# Planning & Zoning Staff Report to the Allentown City Planning Commission September 13, 2022

**Project Title (Number):** Cumberland Apartment Complex (LMA-2022-00015 & LDC-2022-00007)

RE: 6<sup>th</sup> and Cumberland Streets  
LMA-2022-00015 & LDC-2022-00007  
Revised Comments

The Bureaus of Engineering and Traffic have reviewed the subject plans and supporting documentation prepared by Benchmark Civil Engineering Services, Inc. dated August 16, 2022, no revision and offer the following comments and/or recommendations to be addressed in subsequent plan submissions:

Figure 3. Project site plan showing locations of major land uses and sidewalks.

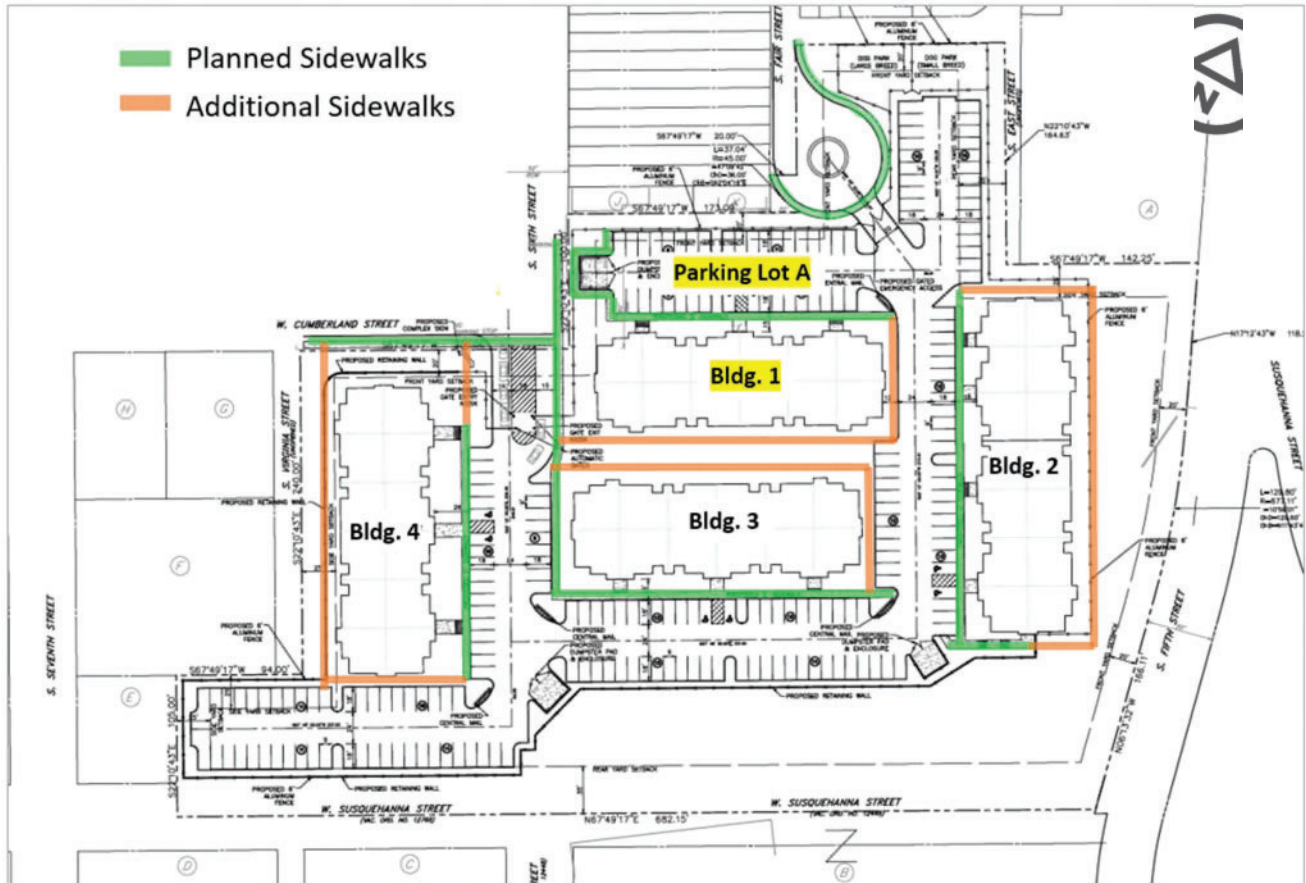
7. Building 1 Location vis-à-vis Parking Lot A – The site plan (depicted in Fig-3 next page) shows Parking Lot A abutting residential uses along its north border. It seems sensible – but not critical in this case – to relocate Bldg. 1 northward to switch locations with Parking Lot A, such that residential uses abut each other thereby avoiding potential land use conflicts that may arise from different activities.

- a. *The applicant may wish to consider switching the location of Bldg. 1 with Parking Lot A and reconfigure the parking and sidewalk layouts because of this change.*

- a. *Staff strongly recommends for the applicant /developer to undertake and submit to the city a traffic impact assessment of the project.*
9. Sidewalks – The planned sidewalks (shown as green lines Fig-3) lack overall connectivity as to encourage walking within the development and engender pedestrian safety. It is strongly recommended for the developer to:

- a. *Install additional sidewalks in areas where normal pedestrian traffic would occur, such as around the residential buildings and near parking lots.*

- b. *Make the effort to connect the interior sidewalks with the sidewalks outside the development.*
10. Lighting – the lighting plan seems adequate for the most part. In addition, however, the developer may wish to:

TITLE:  
**STREET VACATION PLAN**

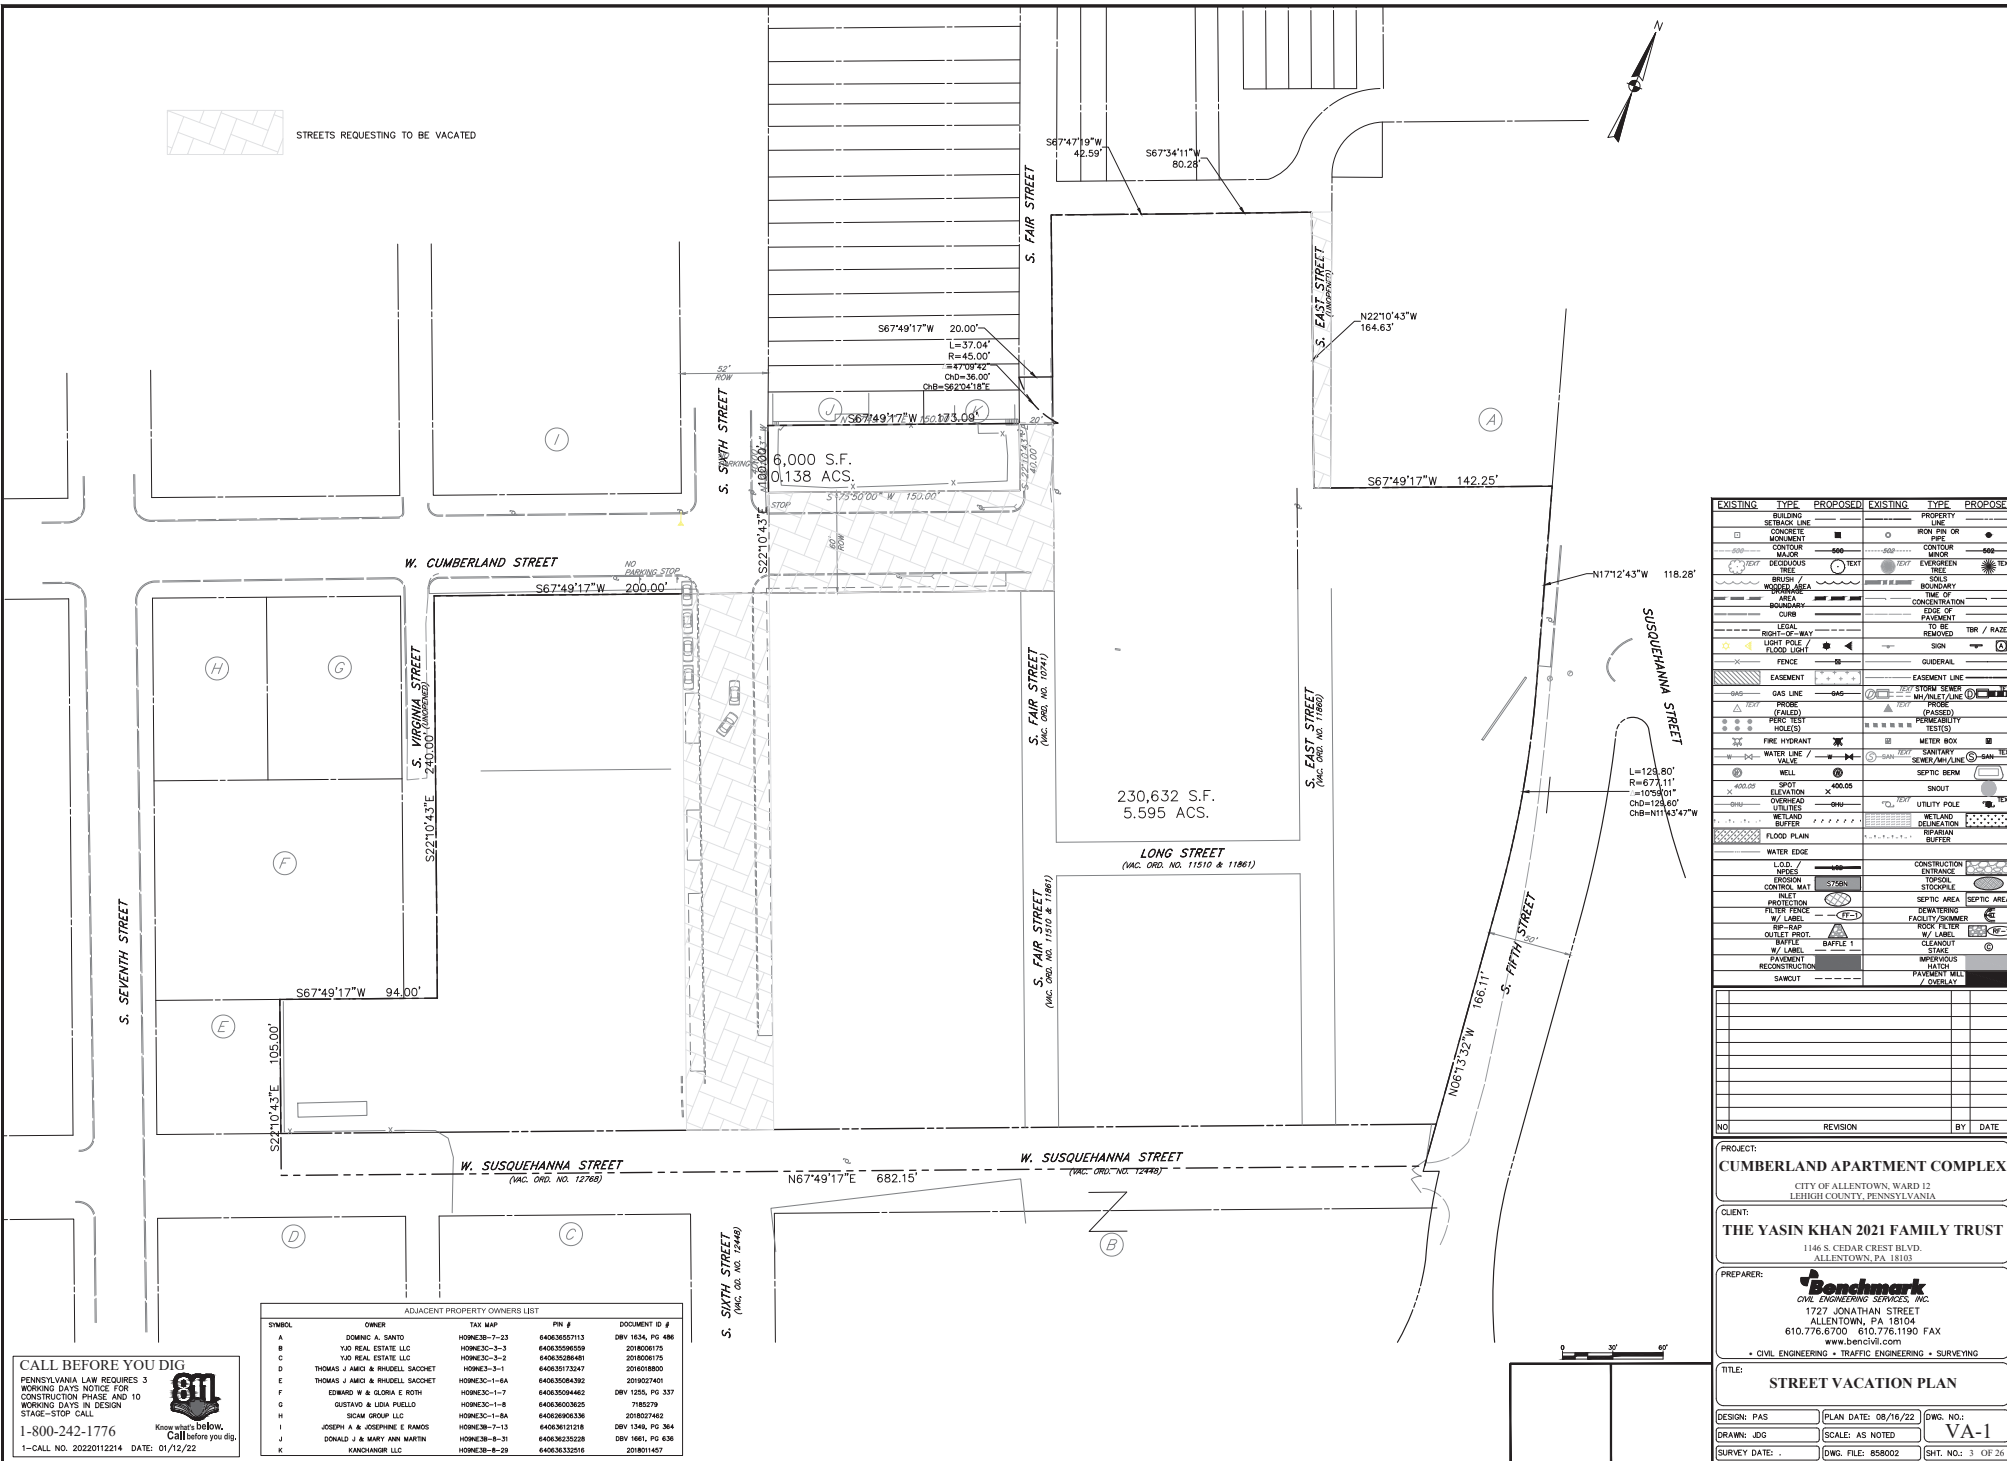
9. Revise the street vacation plan to a lot consolidation plan and include the pertinent lot consolidation information (property line to be deleted, etc).

10. The western limit of the vacation Ordinance 12768 is at the centerline of S Virginia Street.
11. Susquehanna Street from S Virginia St to S 7<sup>th</sup> St should be shown as to be vacated.

12. S Virginia St from Cumberland St to its S Terminus should be shown as to be vacated.
13. Cumberland St from S 6<sup>th</sup> St to S 5<sup>th</sup> St should be shown as to be vacated.

TITLE:  
**SITE PLAN**

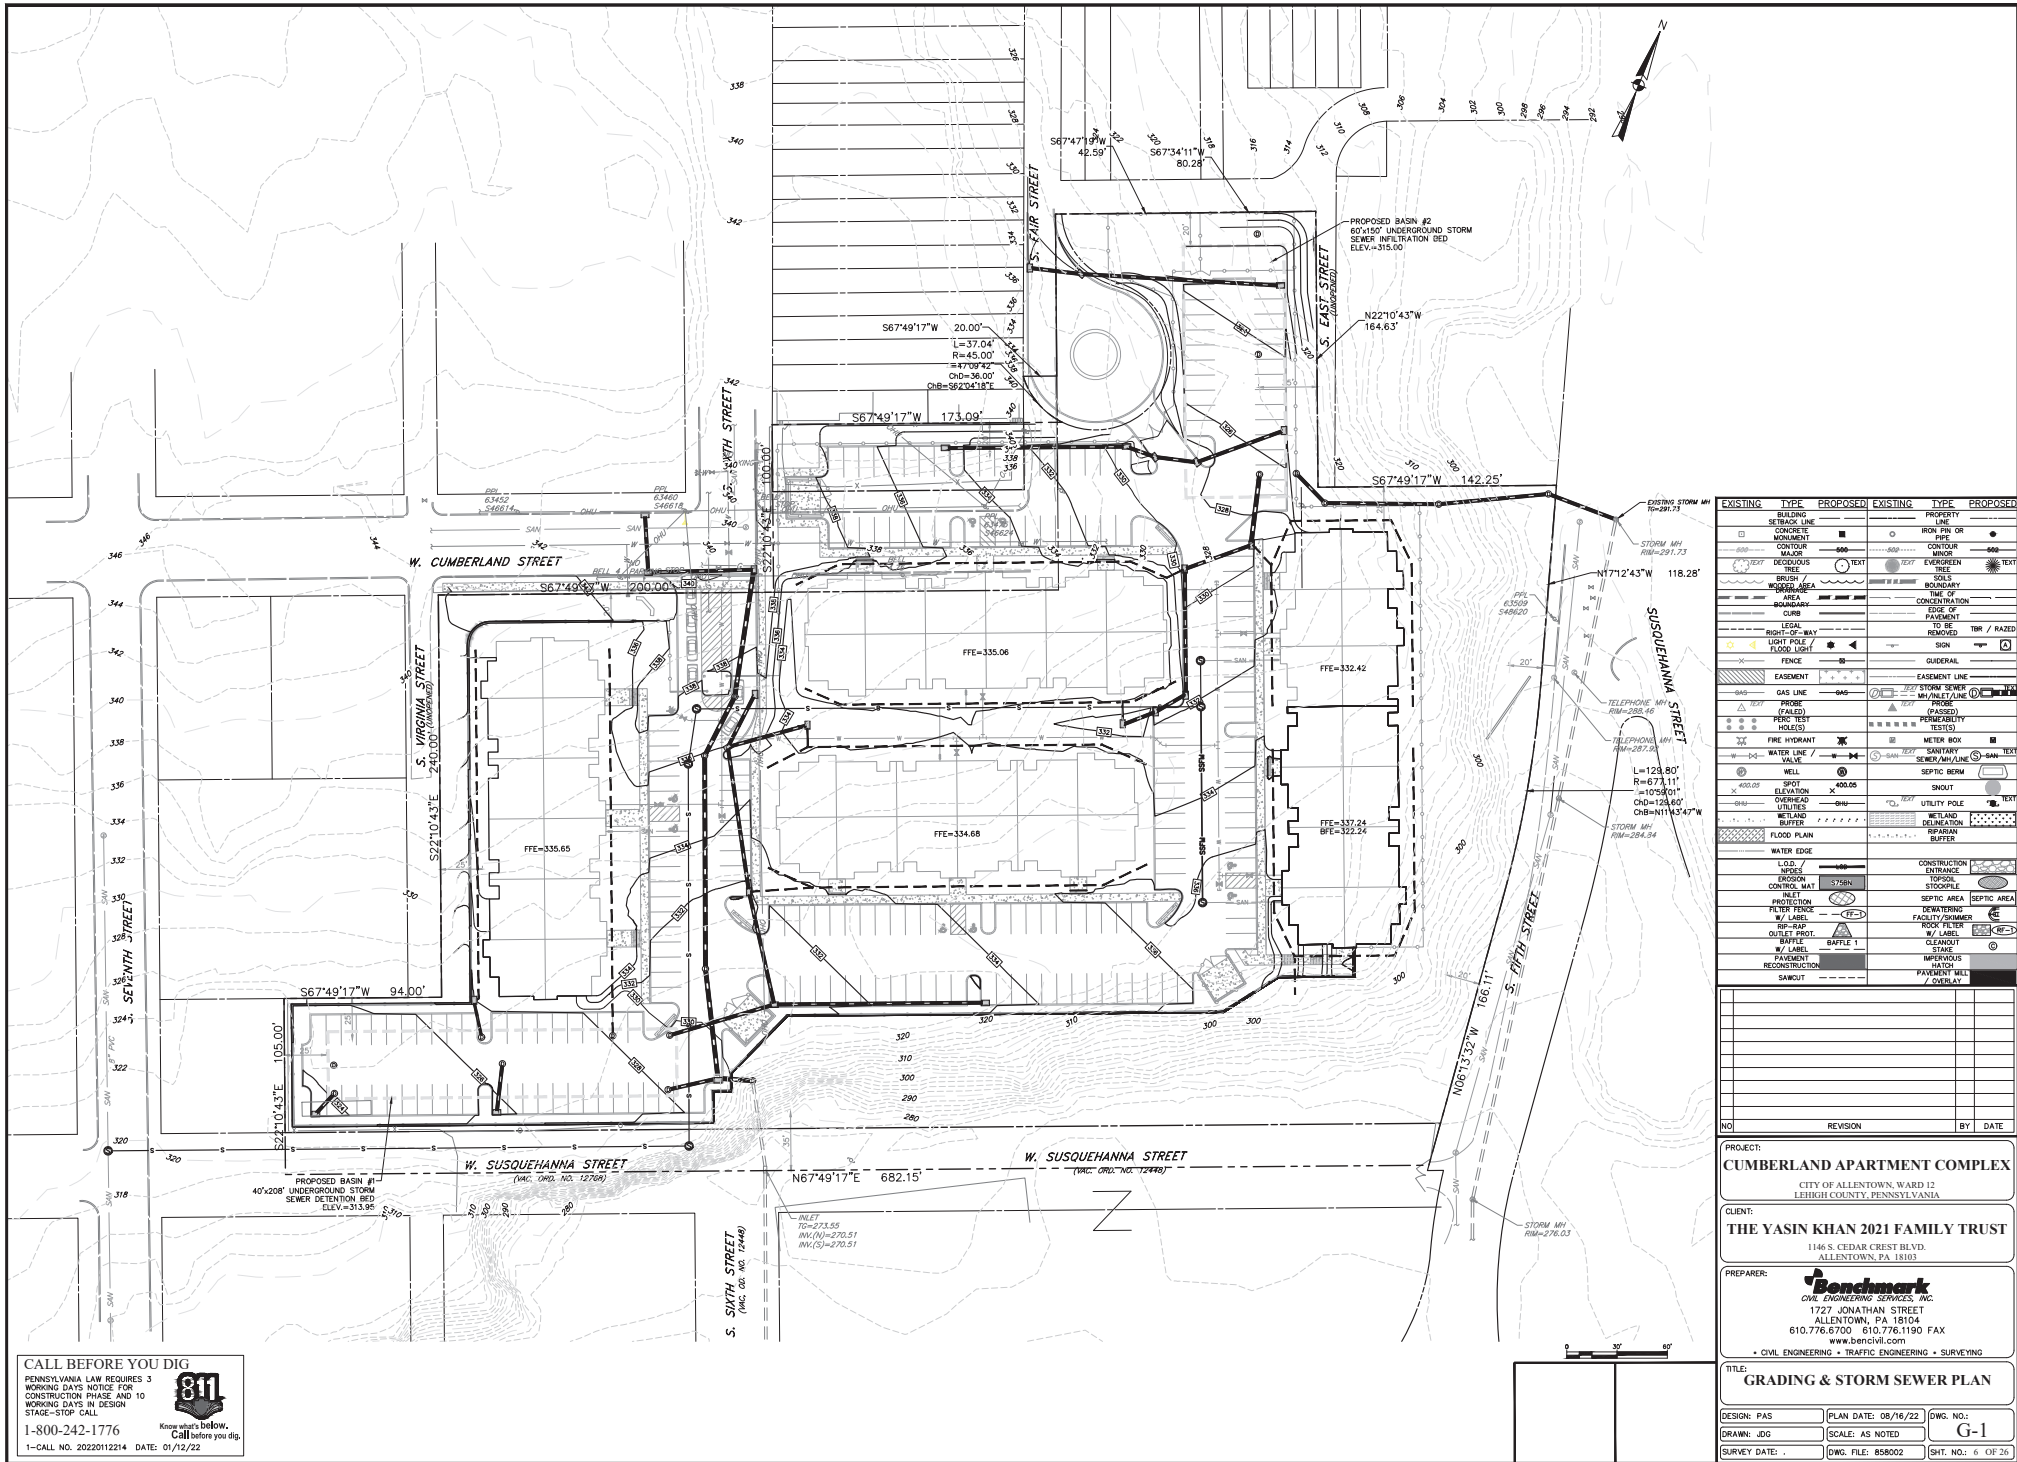
14. The interior property lines within S Fair St should be removed on the site plan.
15. Ownership should be listed for 1025 S 6<sup>th</sup> St.
16. The proposed Fair St cul-de-sac should be shown within existing and proposed right-of-way. The right-of-way line for S Fair St should include the areas along property K and 1025 S 6<sup>th</sup> St. If the plan is to remain as shown property K & 1025 S 6<sup>th</sup> St will need to sign off on the plan and a new Deed will need to be recorded for each property.

21. Provide new ADA ramps on the south west corner of 6th Street oriented for the north-south crossing of Cumberland St with thermoplastic crosswalk.
22. The proposed unit # range for each floor of each apartment should be listed on Sheet 5 for addressing purposes.

23. The following addresses should be labeled on the buildings; Building #1=541 Cumberland Street, Building #2=602 Cumberland Street, Building #3=551 Cumberland Street and Building #4= 520 Cumberland St .

47. The proposed monumentation for the developed lot must be indicated on the site plan. The plan should show each proposed property corners as "monument to be set" (concrete monuments for road right of way frontage, iron pins for all other boundary changes). Also, denote each type and location of the "found" monumentation.

TITLE:  
**POST CONSTRUCTION STORMWATER  
MANAGEMENT PLAN - DETAILS**

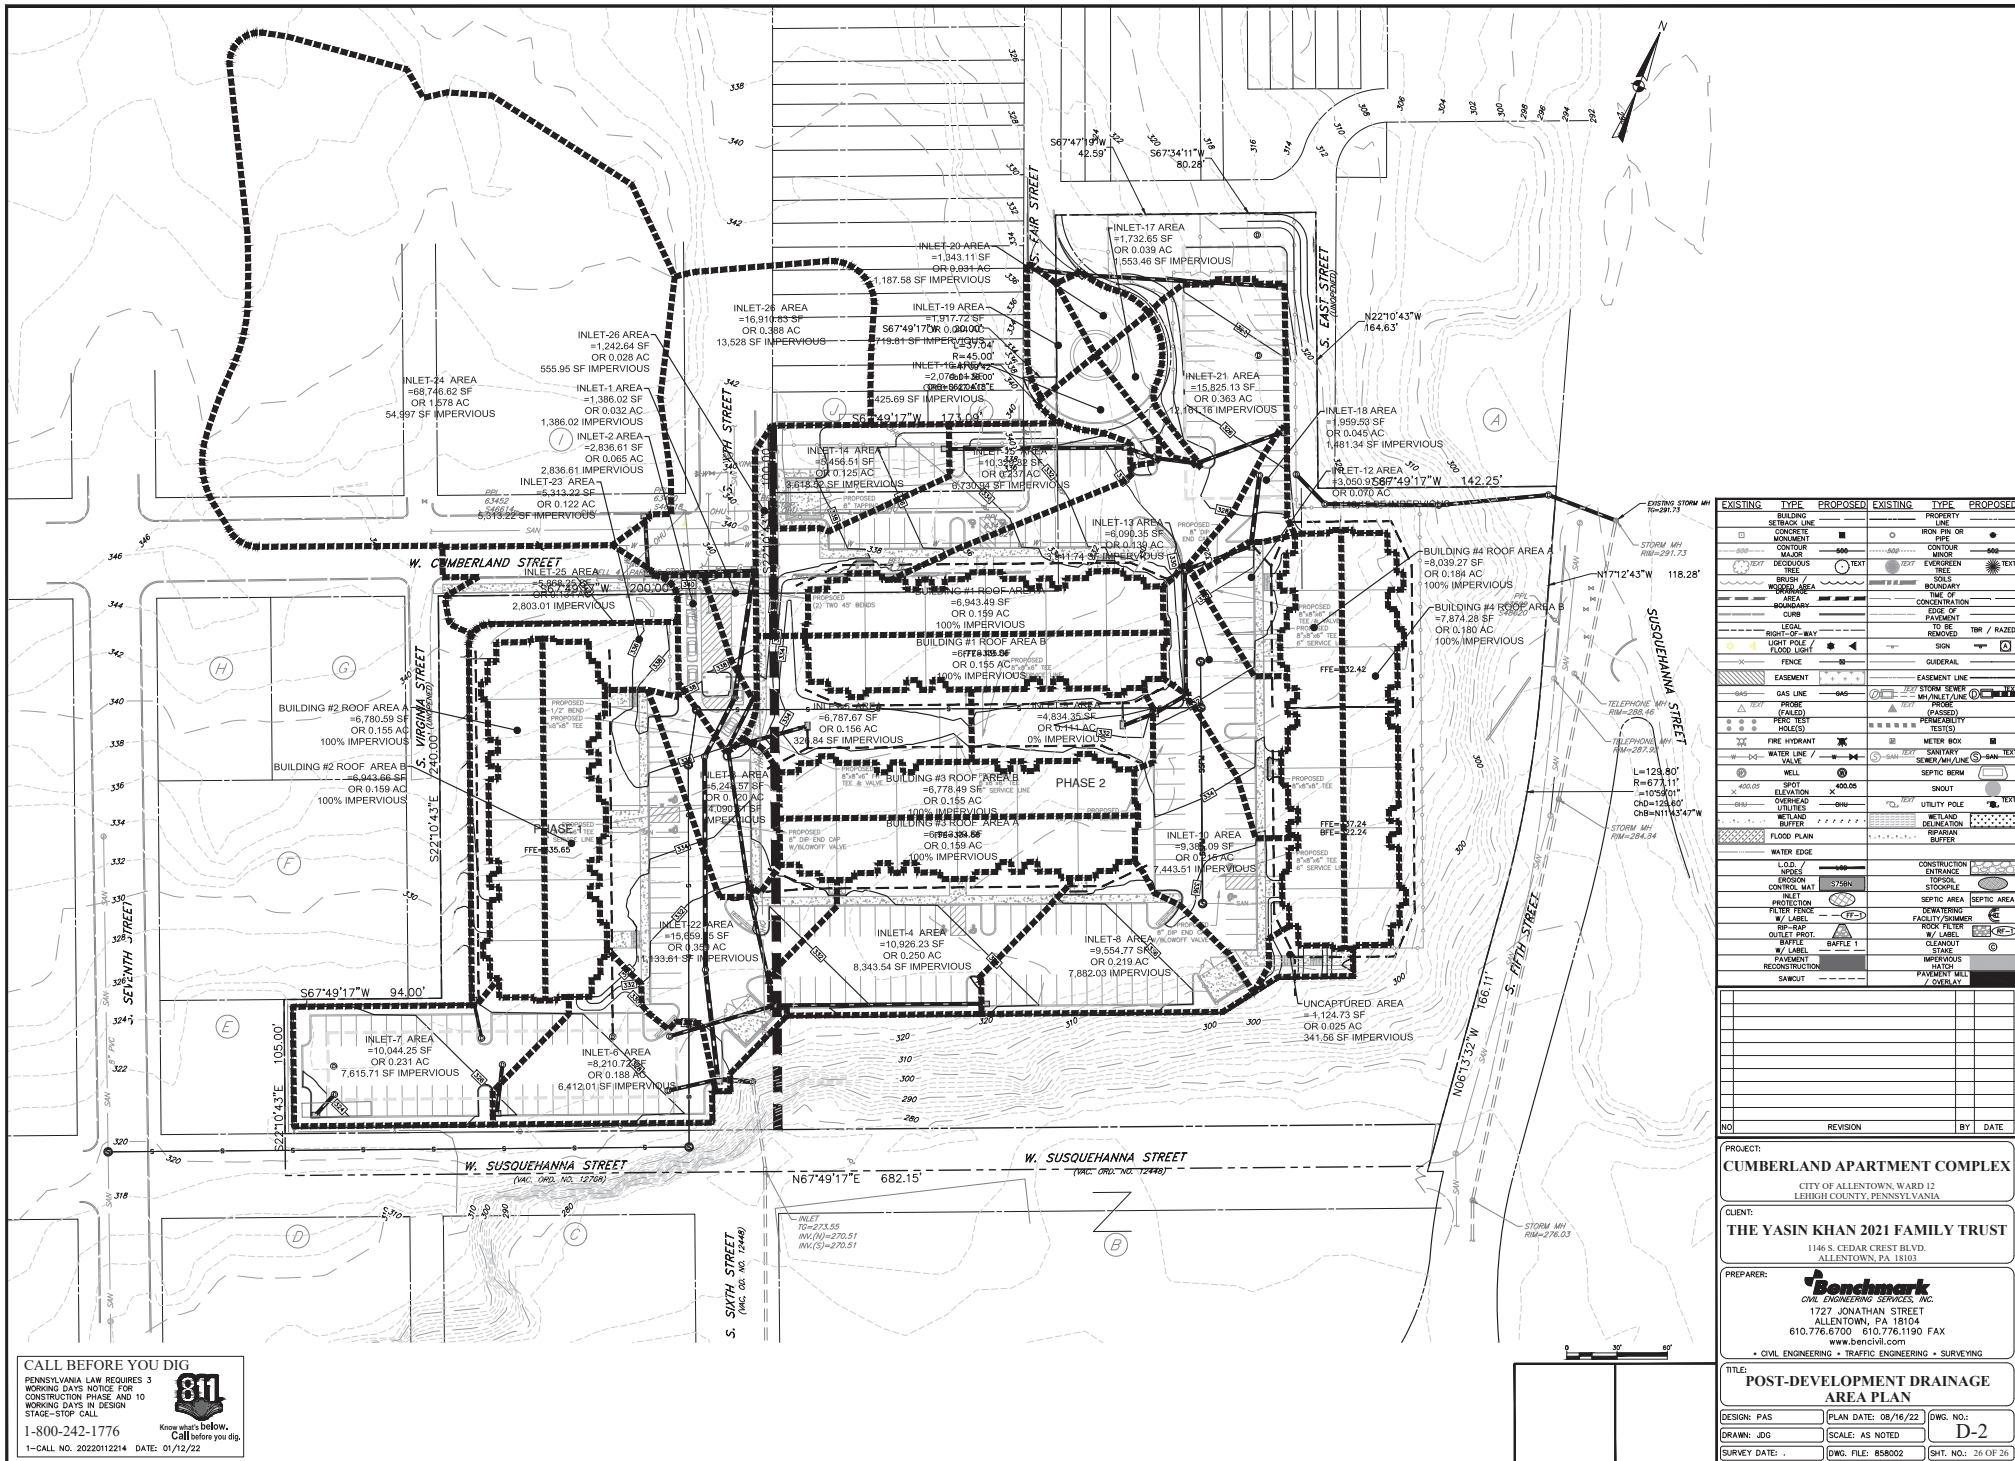
31. The detail sections for the underground basins and the outlet structures do not appear to match the calculations. Provide a plan view detail of the underground basins.
